TECHNICAL SERVICE BULLETIN- "THIS IS NOT A RECALL"

| DOC # | PROCESS NAME | PAGE | REVISION | STATION | BY | DATE |
|----------------|--|--------|----------|---------|--------|----------|
| TSB1401 | MANDATORY FUEL EXTENSION HARNESS REPLACEMENT, 191/210 GAS UNITS | 1 OF 1 | | SER | DBaker | 5/5/2014 |

The Purpose of TSB1401 is to notify the Dealers of a change in the Fuel Extension Harness to prevent possible breakdown of the unit.

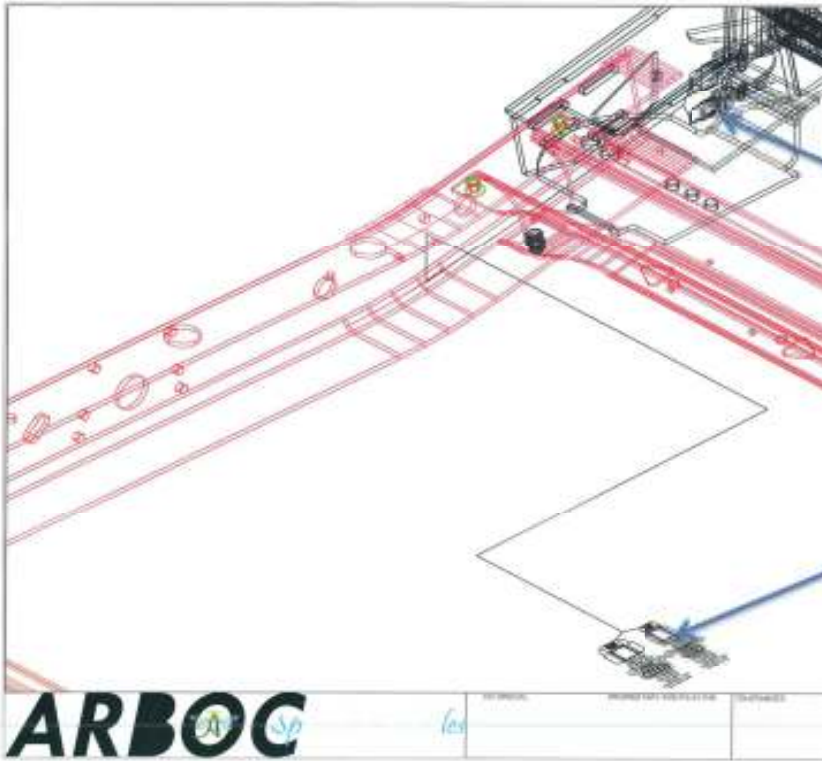
Location: Harness end is on Driver side frame rail above

Location: Harness end is under cover plate inside bus above gas tank in floor

Step 1: Remove cover plate on floor inside bus above gas tank and unplug harness as indicated in picture.

Step 2: Unplug other end of harness on chassis rail as indicated in picture.

Step 5: Plug new harness into location above gas tank and feed the rest of the harness down hole in floor. Re-install cover plate on floor.

Step 6: Plug new harness into existing wiring on frame rail.
